Burlington Design Advisory Board

ZP-24-276; 206-208 Dale Road (RL, Ward 4) Wild Dale, LLC / Matt Brouillard
Proposed construction of a new duplex on existing vacant lot created under ZP-24-159. (Project Manager, Mary O’Neil)

MEMORANDUM

To: The Design Advisory Board
From: Mary O'Neil, AICP, Principal Planner
RE: ZP-24-276
Location: 206-208 Dale Road
Date: July 23, 2024

JPF Architecture, PLLC
802.318.3947
jpfarchitecture.com

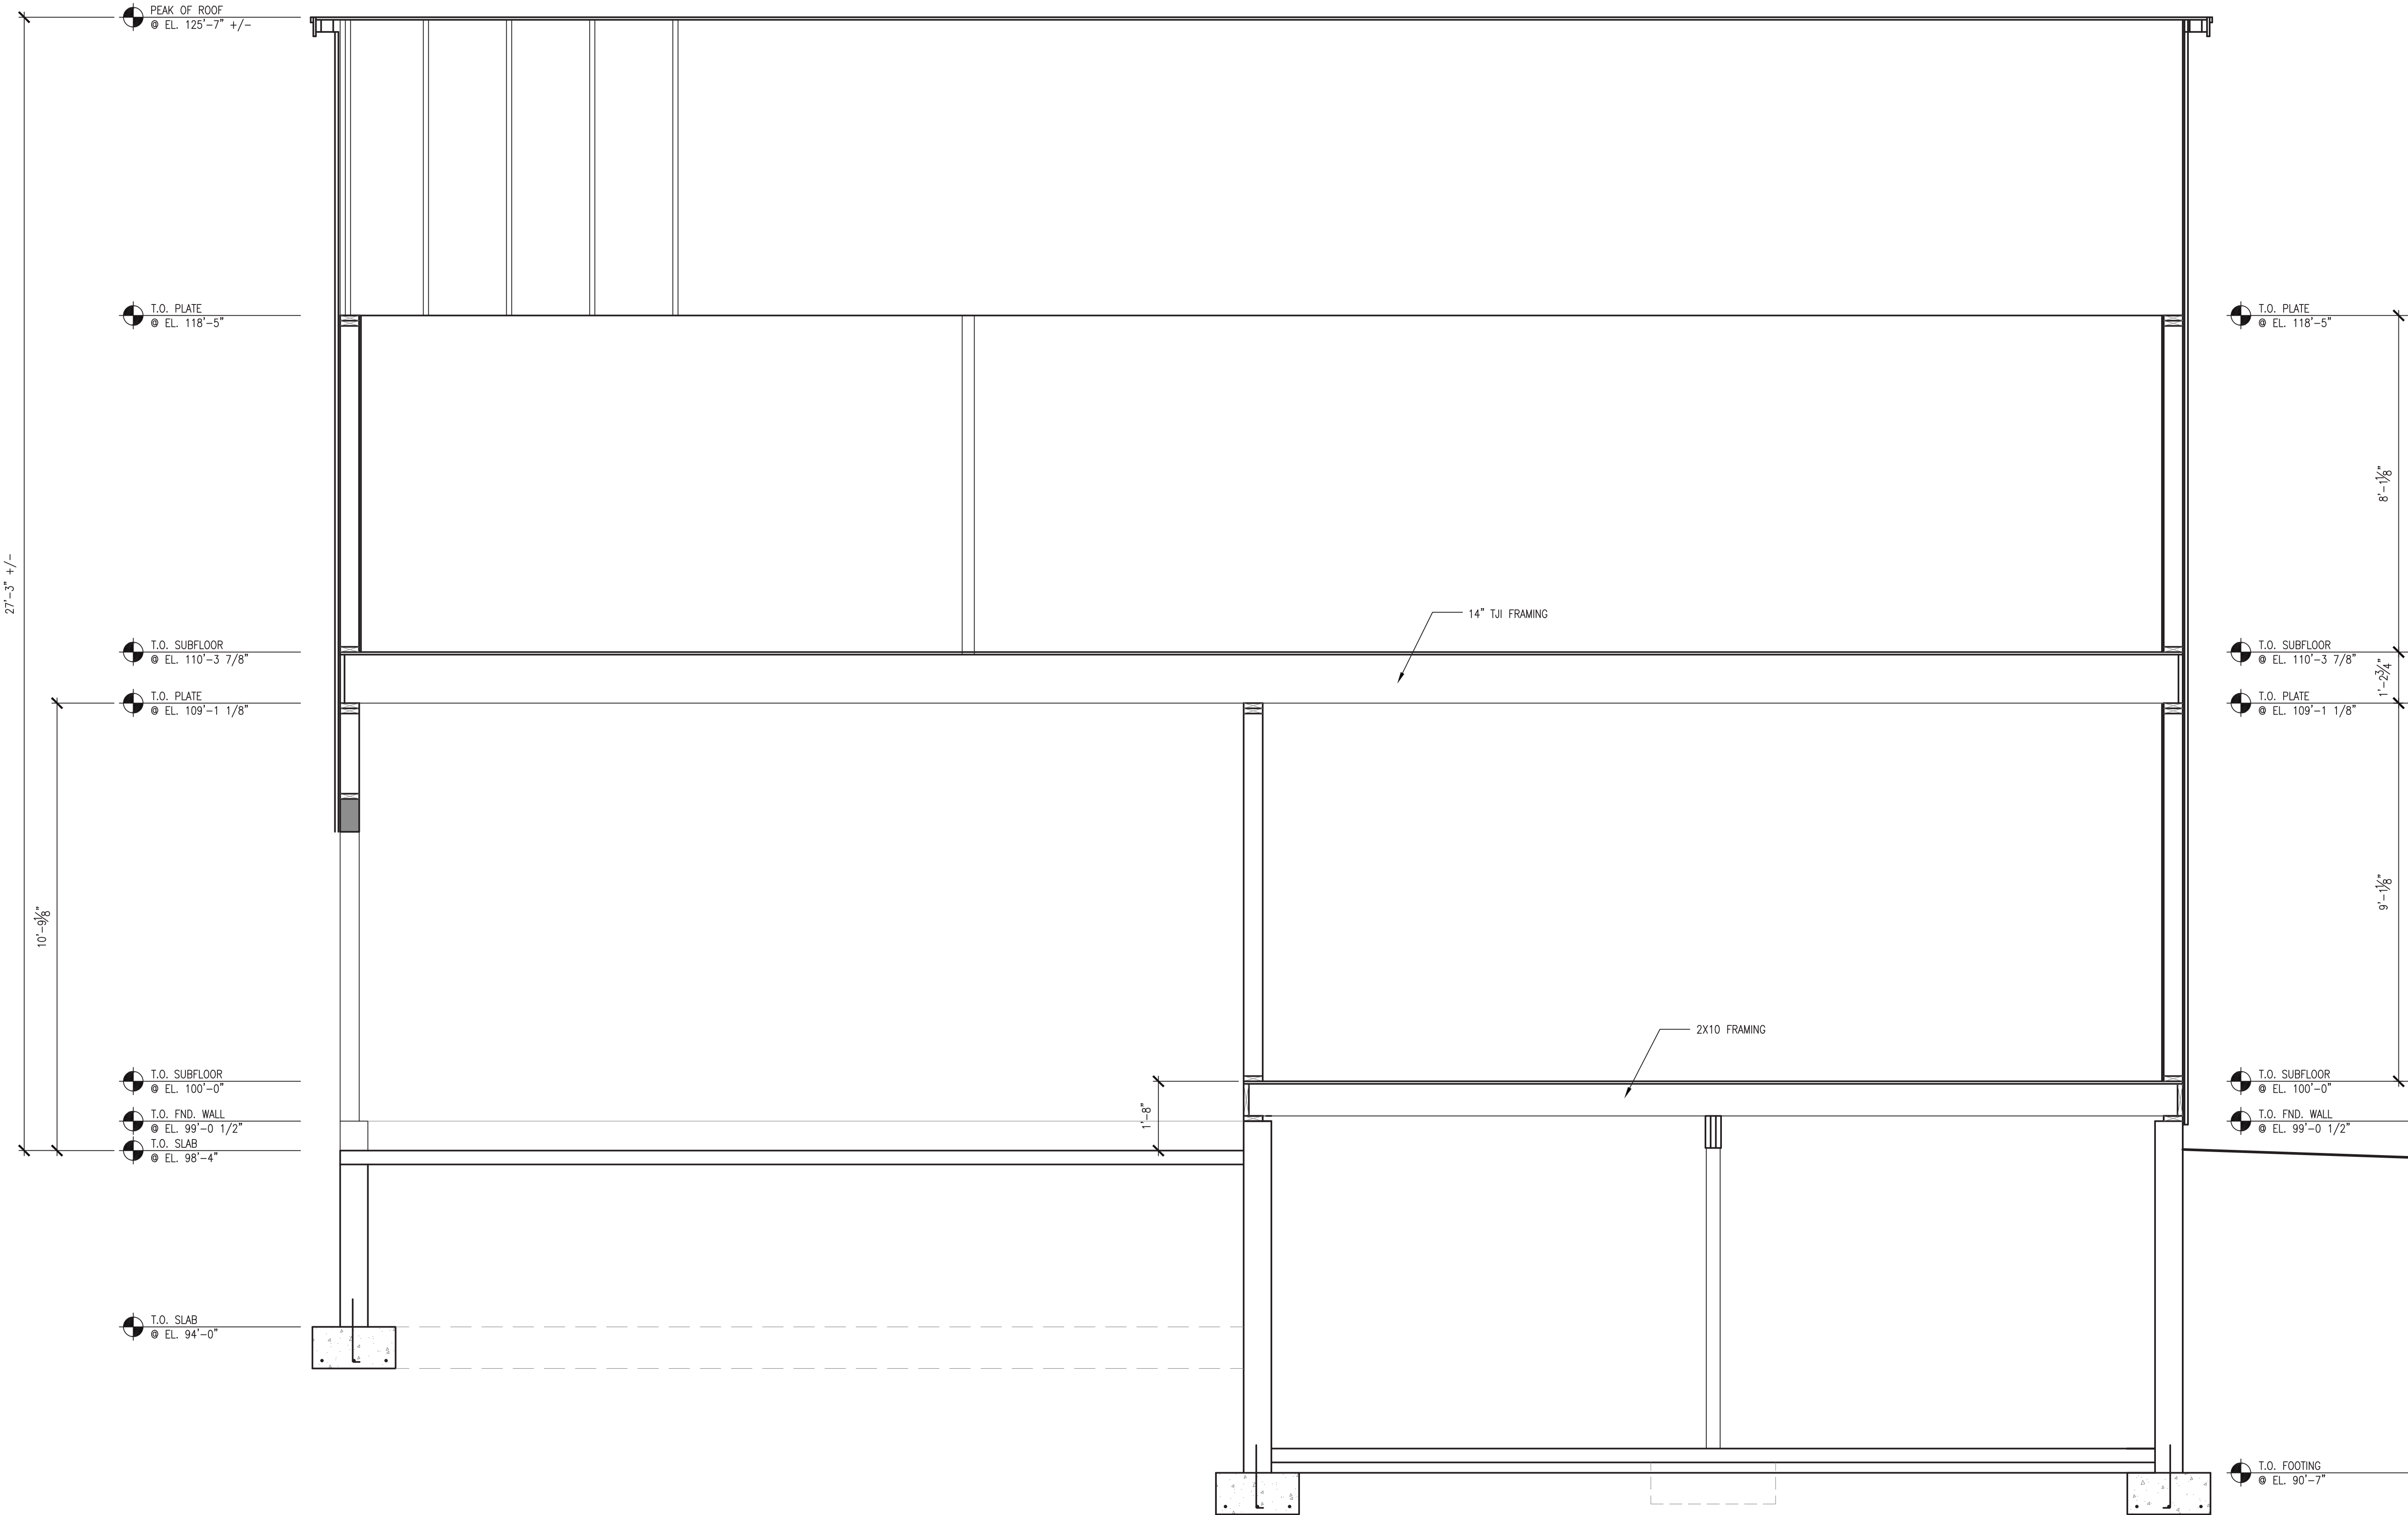
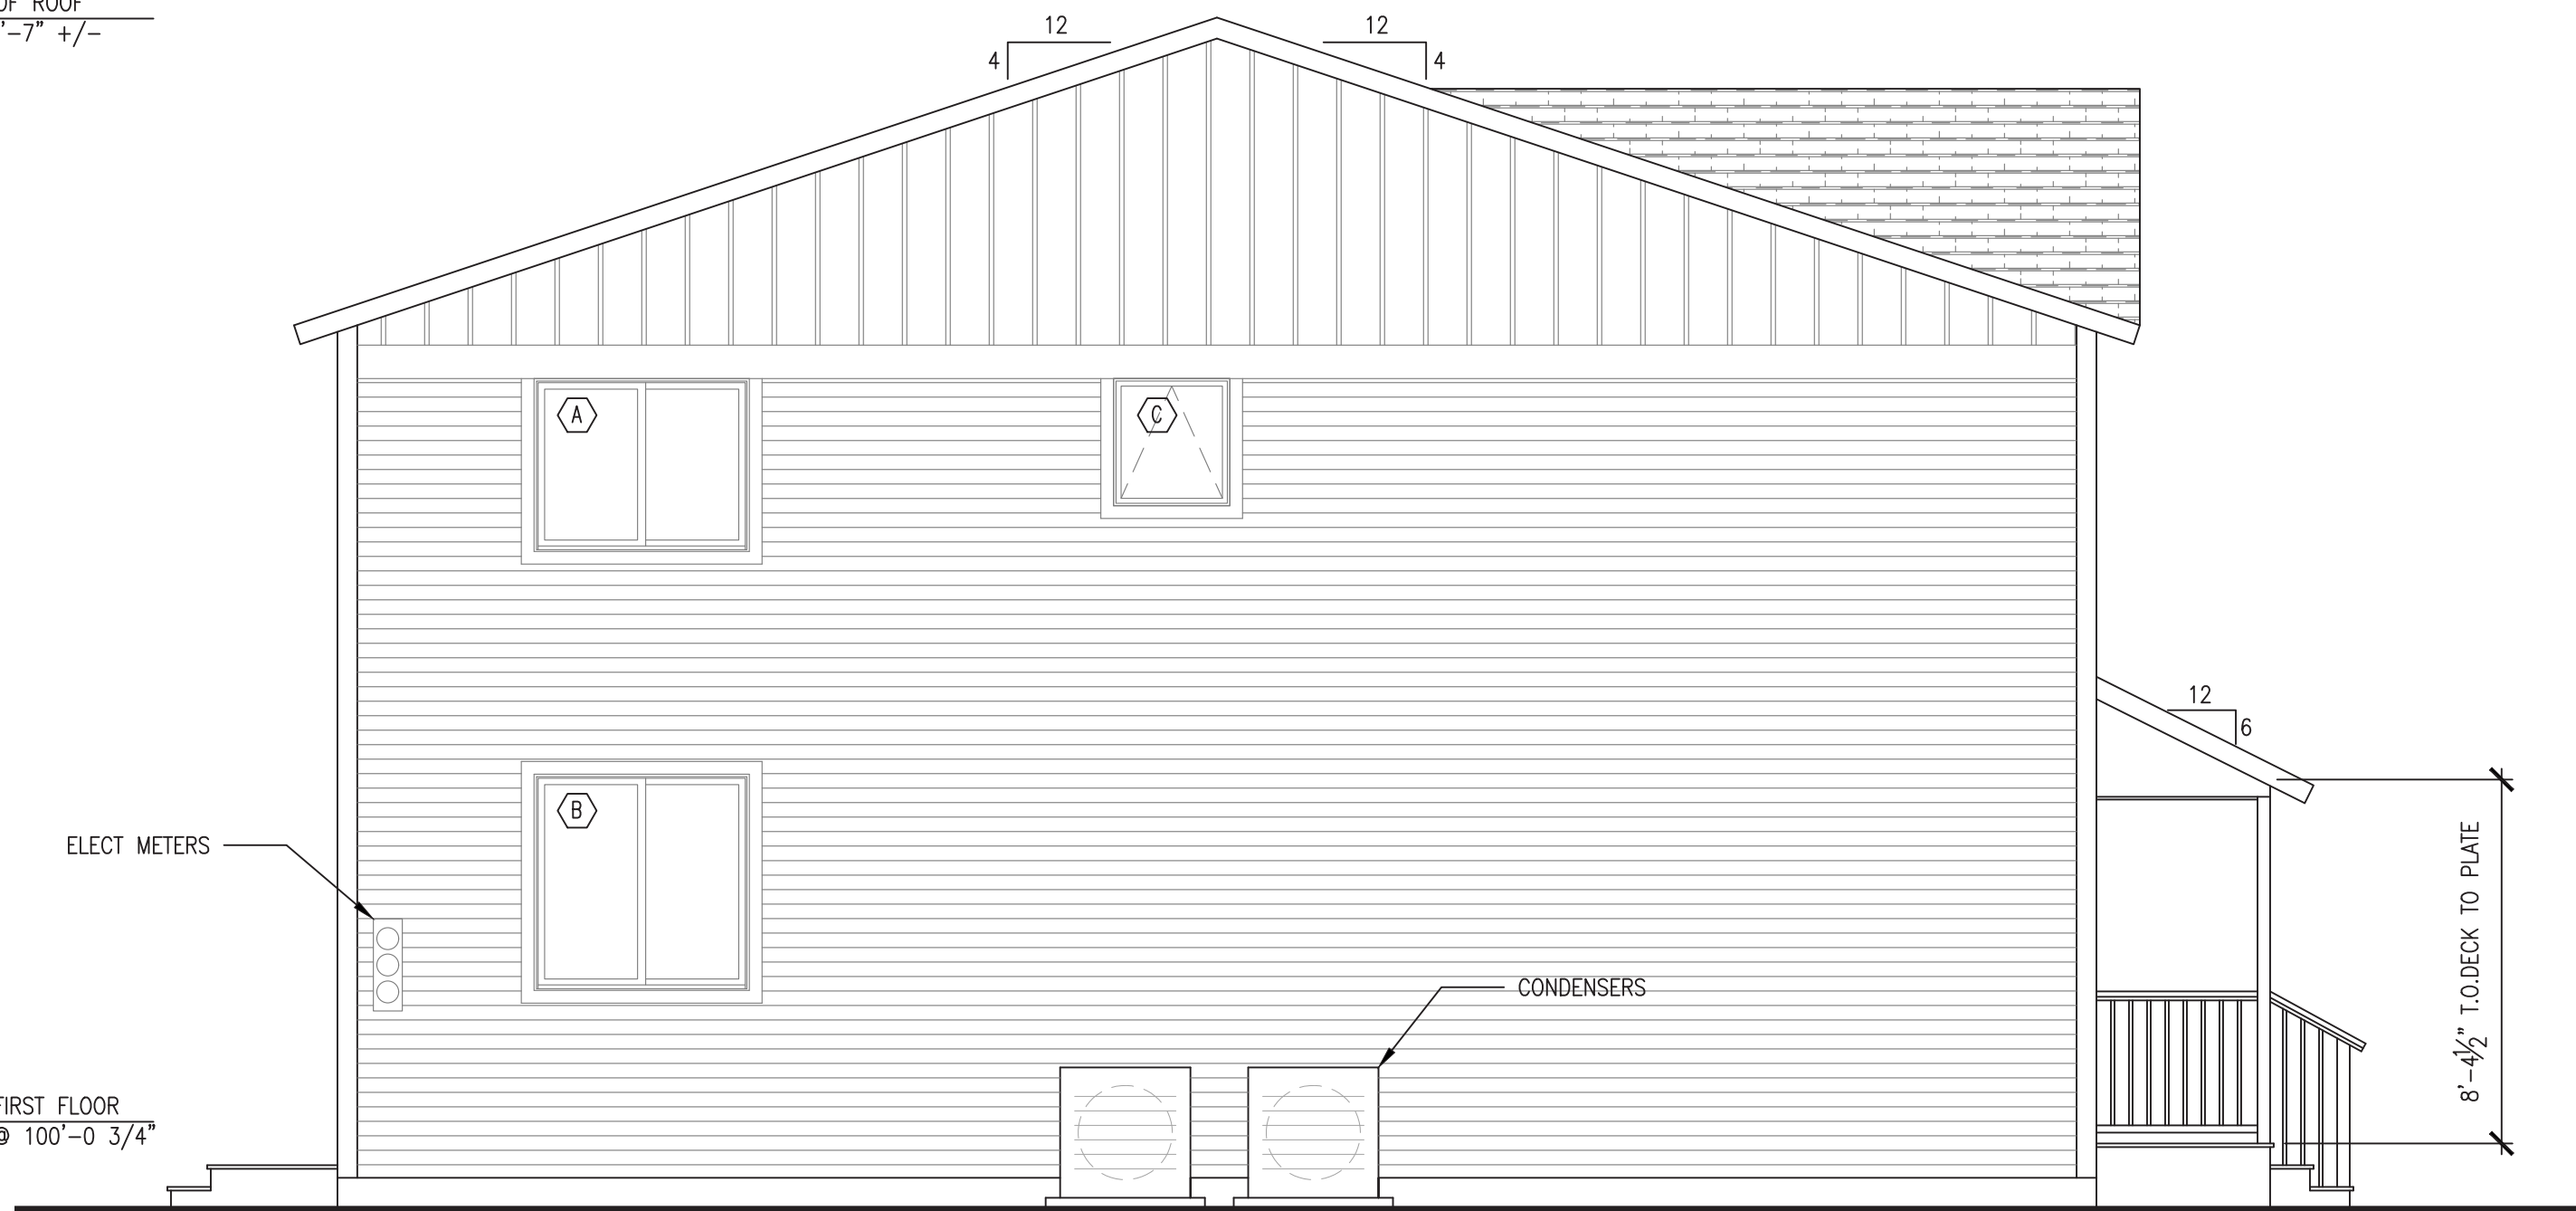
Condensing units are illustrated at the northwest (side) elevation. Mailboxes are adjacent to front entrances. Trash and recycling will be located within the garages. Utility meters are located on a side (northwest) elevation. Reference is made to Plan A2.1.

There remain large expanses of blank walls on the north and south elevations that could improve the livability of the units and provide additional interior daylighting if more windows were included. To successfully achieve these goals, a revised floor plan is recommended, placing interior stairs along interior party walls rather than along exterior walls.

Windows have been symmetrically placed across all elevations. The deficiency in the plan is the dearth of windows on north and south elevations, resulting from the proposal to arrange interior stairs along exterior walls. (This was a similar weakness

Plan A2.1 defines the intention of asphalt shingle roofing, composite board and batten in the gable ends and vinyl siding for the bulk of the structure. All are considered acceptable for new construction.

6. A revised floor plan is strongly recommended; placing interior stairs along party walls to accommodate more windows along northwest and southeast elevations. Revisions will allow for expanded opportunities for daylight into interior rooms, increased air circulation, and an improved floor plan allowing greater resident enjoyment.
